nacht&lewis

To all bidders for furnishing all labor and materials necessary and required for constructing the above referenced project. This Addendum has been prepared to clarify, modify, delete, or add to the original or previously modified Contract Documents for the above referenced project. Revisions to items listed here shall supersede description thereof prior to above date. All conditions not specifically referenced here shall remain the same. It is the obligation of the General Contractor to make subcontractors aware of any items herein that may affect submitted bids.

EL DORADO MIDDLE SCHOOL
MULTI-PURPOSE BUILDING UPGRADES
1750 WEST ST, CONCORD, CA 94521

FOODSERVICE EQUIPMENT FLOOR PLAN

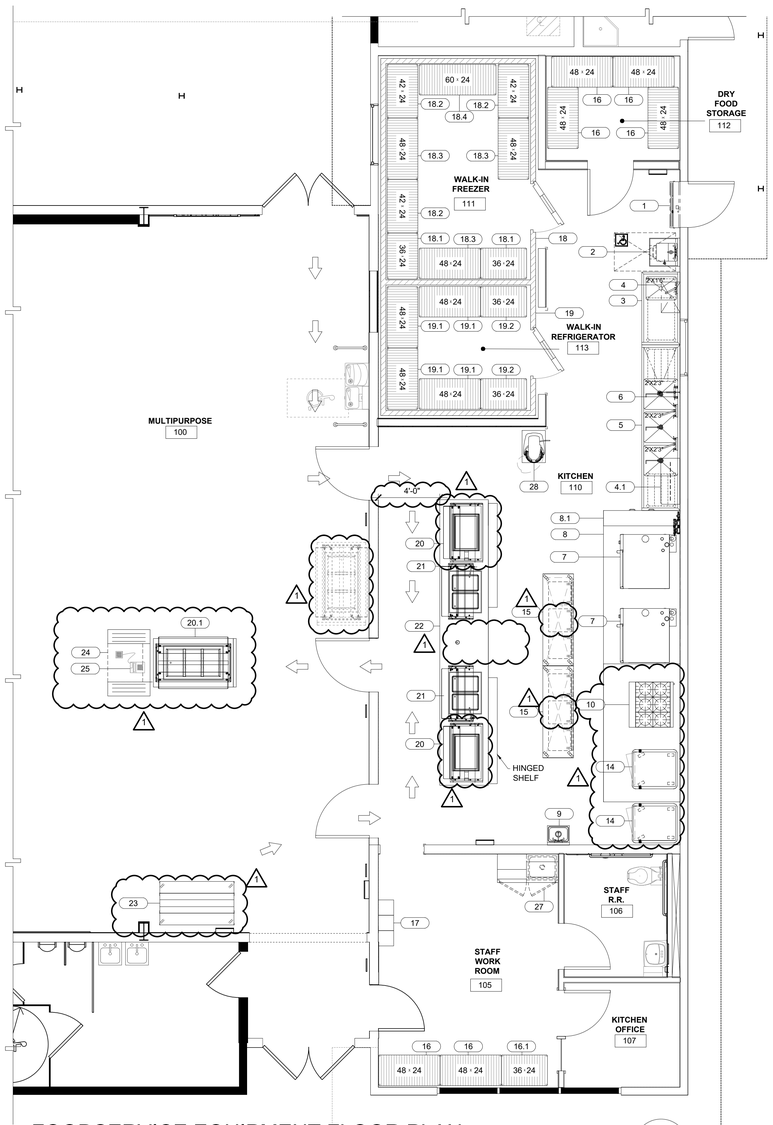
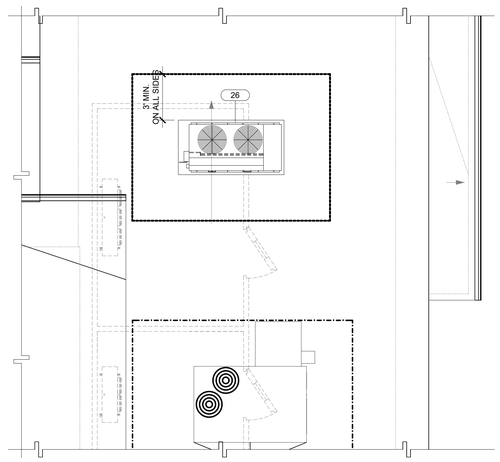
AD01.8 Sheet FS1.1 – FOODSERVICE EQUIPMENT FLOOR PLAN

- REPLACE the Sheet in its entirety with provided attachment **AD01-2**
- Changed serving line configuration and load center location,
- Changed salad bar location
- Changed milk cooler location
- Add a mobile point of sale unit.
- Moved serving line slightly for clearance.
- Removed griddle, char broiler
- Added mobile warmer
- Added third drawer to the mobile tables
- Mixer model number changed

FOODSERVICE EQUIPMENT PLUMBING PLAN

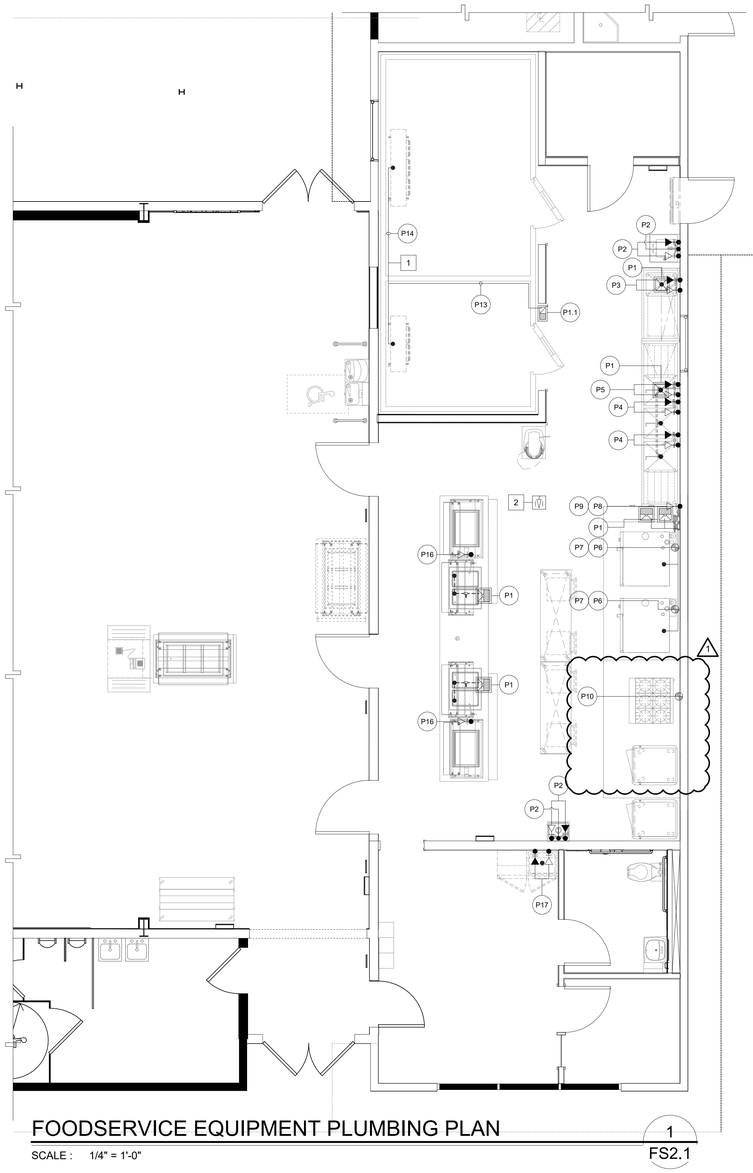
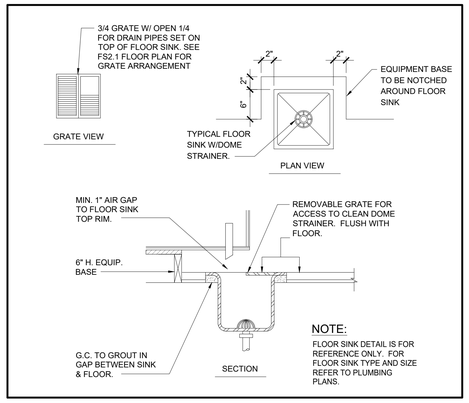
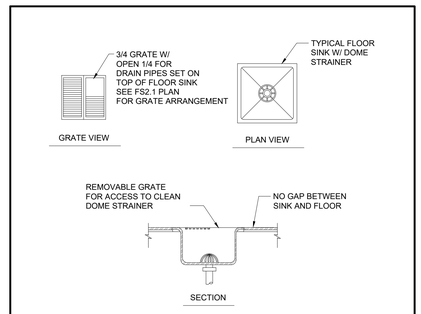
AD01.9 Sheet FS2.1 - FOODSERVICE EQUIPMENT PLUMBING PLAN

- REPLACE the Sheet in its entirety with provided attachment **AD01-3**
- Updated gas connection requirements for equipment change under hood

FOODSERVICE EQUIPMENT ELECTRICAL PLAN

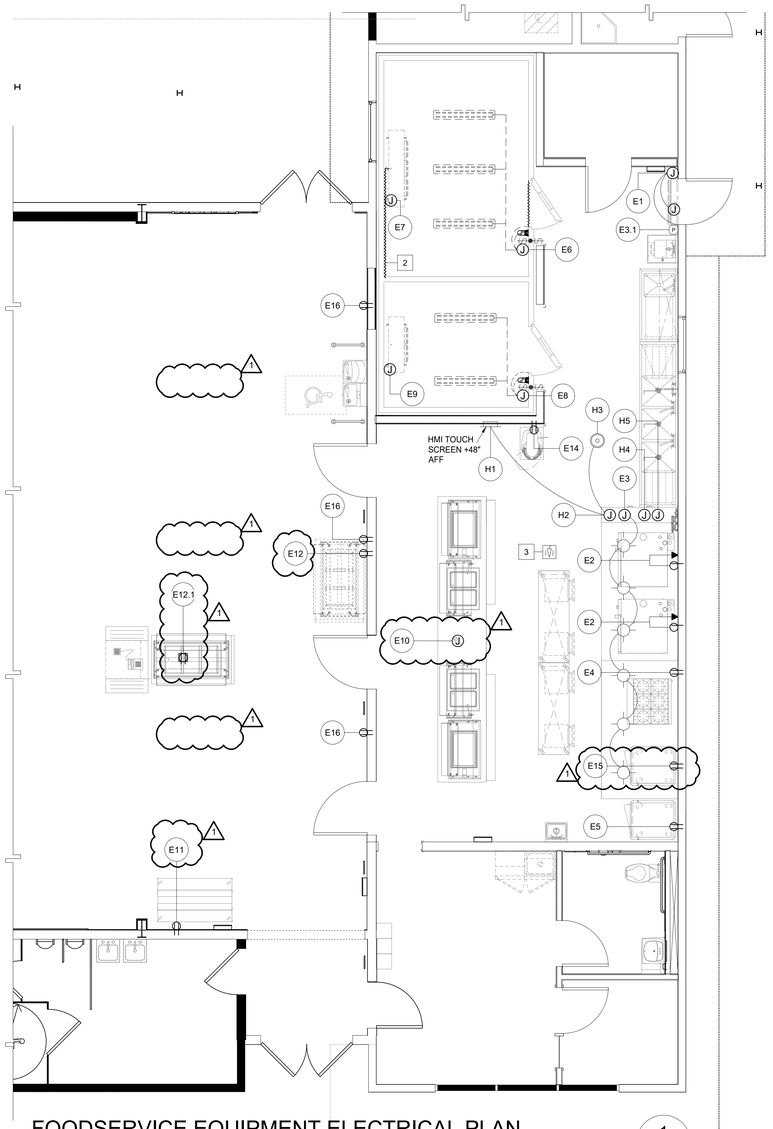
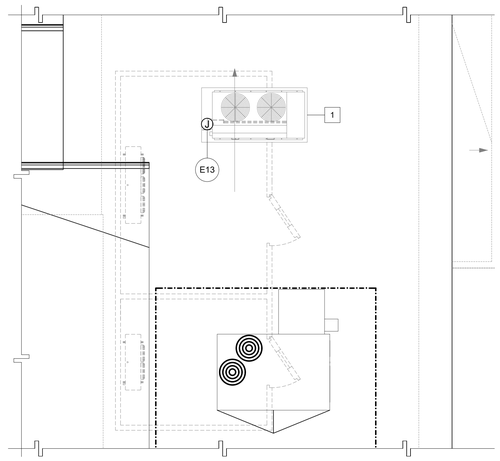
AD01.10 Sheet FS3.1 - FOODSERVICE EQUIPMENT ELECTRICAL PLAN

- REPLACE the Sheet in its entirety with provided attachment **AD01-4**
- Updated coil freezer coil power requirement (latest code-compliant refrigeration revision)
- Load center at serving line location and requirements changed
- Swapped electrical location with milk cooler and salad bar.
- Removed floor outlets and changed E15 to warmer under hood with shunt trip breaker.
- Power changed for remote refrigeration (latest code-compliant refrigeration revision)

FIRE SYSTEM PLAN VIEW

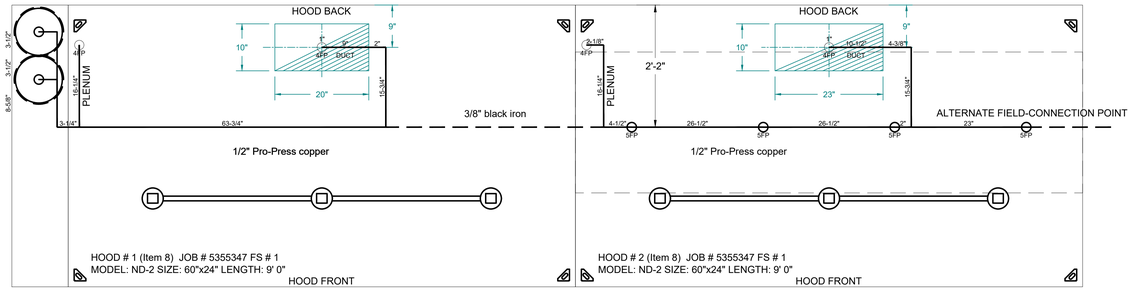
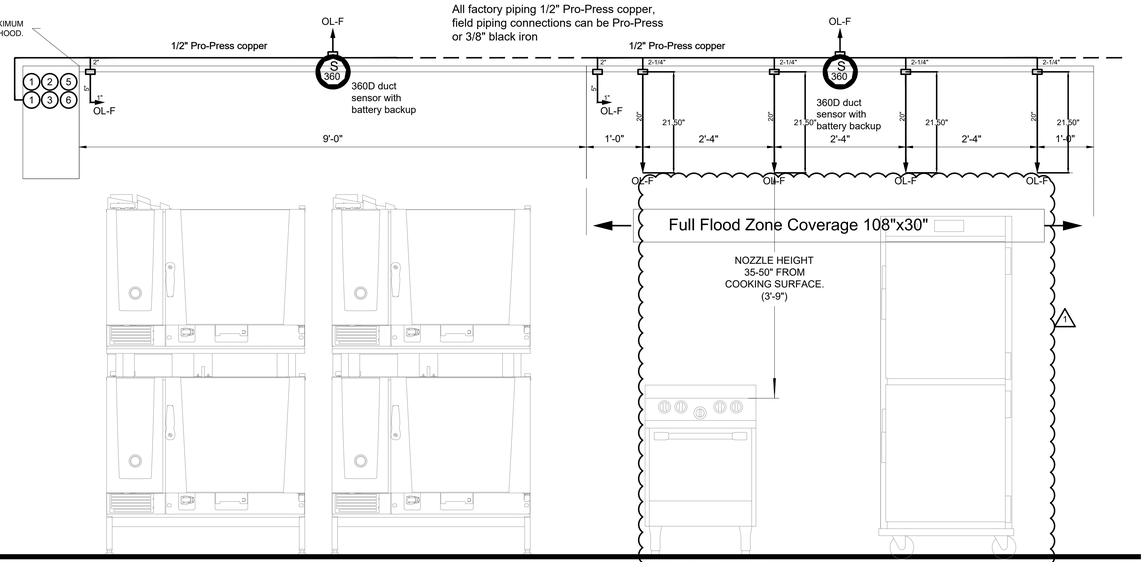
AD01.11 Sheet FS5.4 - FOODSERVICE EQUIPMENT EXHAUST HOOD DETAILS

- REPLACE the Sheet in its entirety with provided attachment **AD01-5**
- Update equipment under hood.

REFRIGERATION RACK OUTLINE DRAWING (A) FS7.1

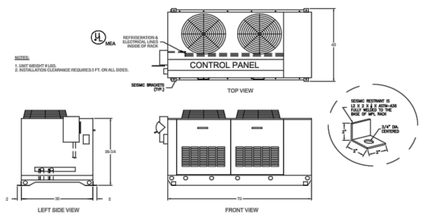
AD01.12 Sheet FS7.1 - FOODSERVICE EQUIPMENT REMOTE REFRIGERATION

- REPLACE the Sheet in its entirety with provided attachment **AD01-6**
- Update remote refrigeration unit to meet new code compliant refrigeration.

J PLATFORM DETAIL

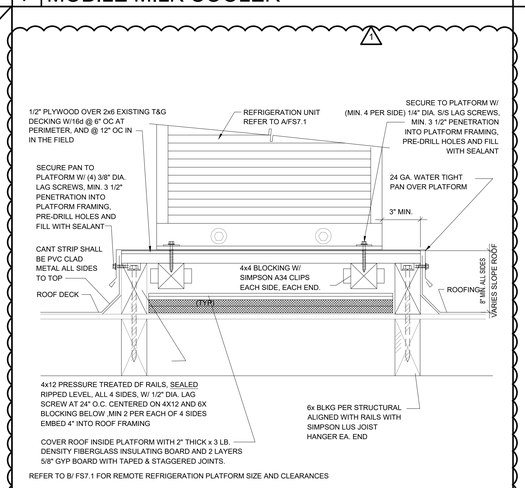
AD01.14 Sheet FS8.3 – FOODSERVICE EQUIPMENT ANCHORAGE DETAILS

- REMOVE detail B/FS8.3
- REMOVE detail D/FS8.3
- ADD detail J/FS8.3 for refrigeration platform.

ELEVATION

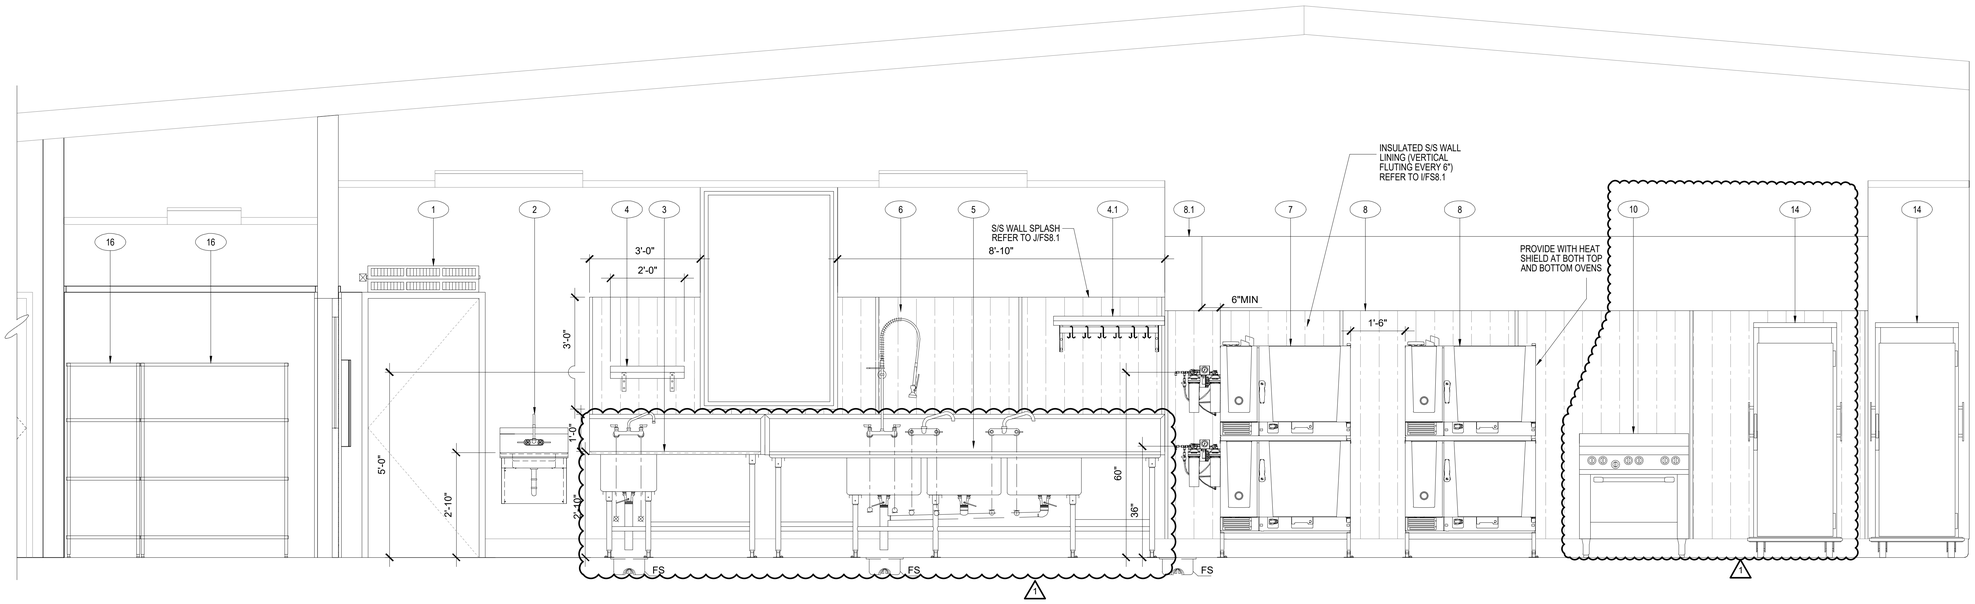
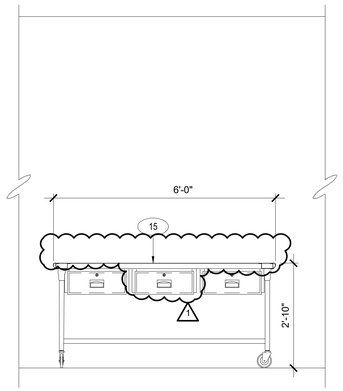
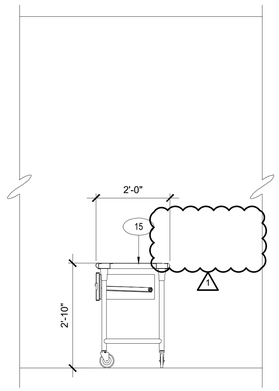
AD01.15 Sheet FS9.1 – FOODSERVICE EQUIPMENT ELEVATIONS

- REPLACE the Sheet in its entirety with provided attachment **AD01-9**
- Updated 3 compartment sink, under hood equipment, removed splash, and added drawers to elevation.

FS9.3

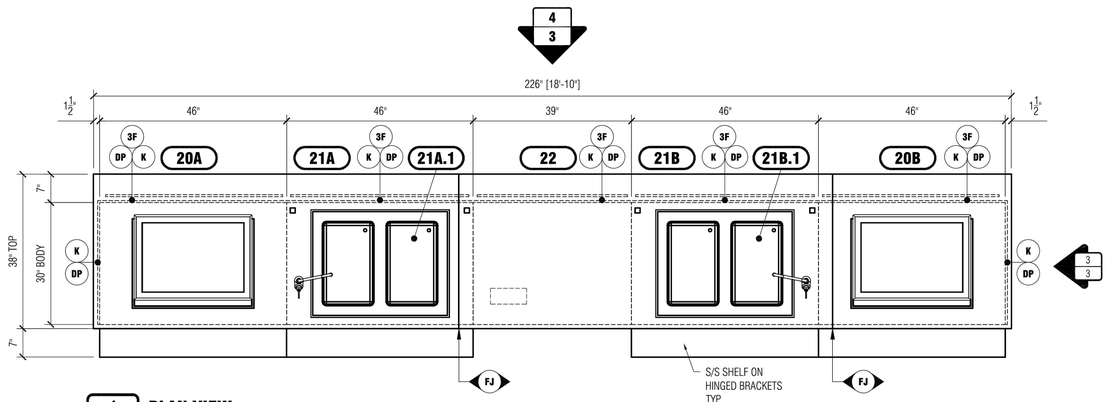
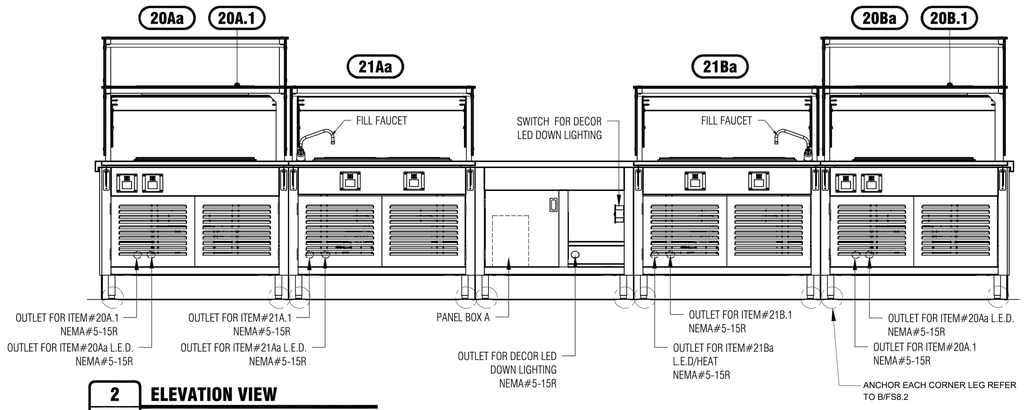
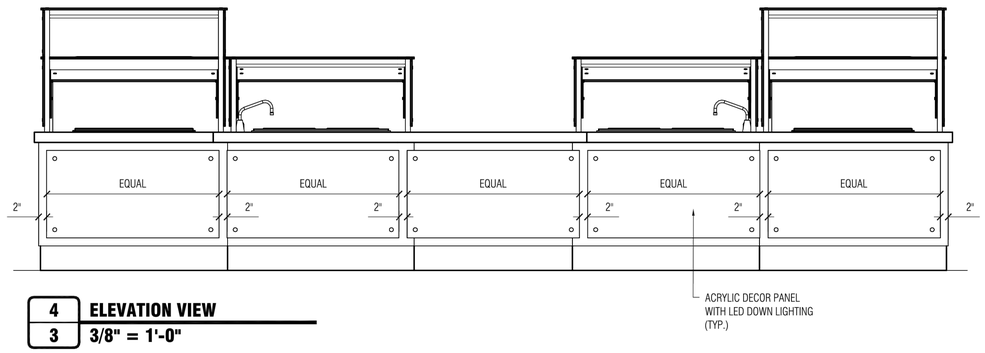
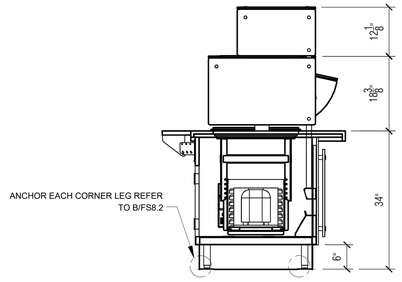
AD01.17 Sheet FS9.3 – FOODSERVICE EQUIPMENT SERVING LINE

- REPLACE the Sheet in its entirety with provided attachment **AD01-11**
- Updated serving line equipment.
